THE STATE EDUCATION DEPARTMENT / THE UNIVERSITY OF THE STATE OF NEW YORK / ALBANY, NY 12234

Re: **COVID 19 Reopening Guidance – Facilities Clarifications**

**Office of Facilities Planning, New York State Education Department August 17, 2020
COVID-19 Reopening Guidance – Facilities Issues Clarifications**

4. **FAQ No.11 (Revised)**

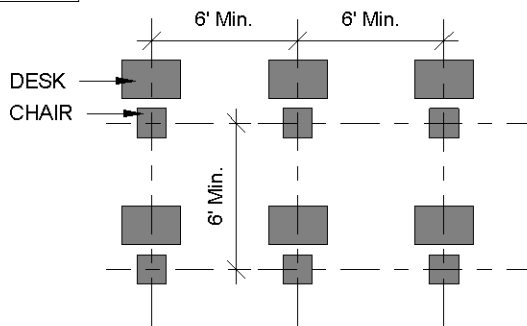
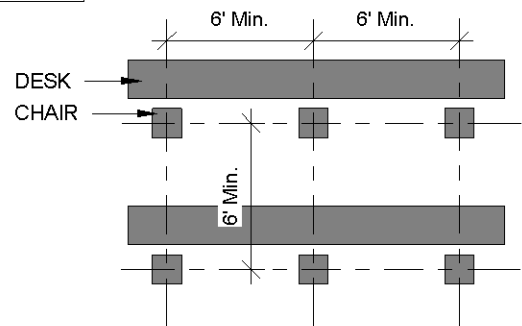
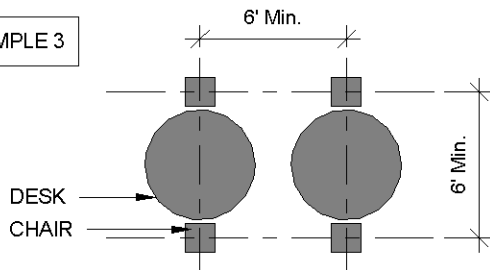
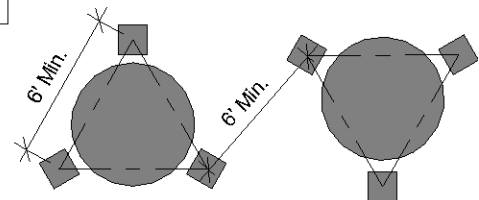
Where do we take measurements from to establish social distancing; for example in the layout of furniture/equipment/etc.?

To achieve acceptable social distancing between the occupants of classroom desks, chairs and teaching consoles, establish a minimum of 6' separation measured to the centerline of individual's space. Measurements should be taken in a manner consistent with the example diagrams below.
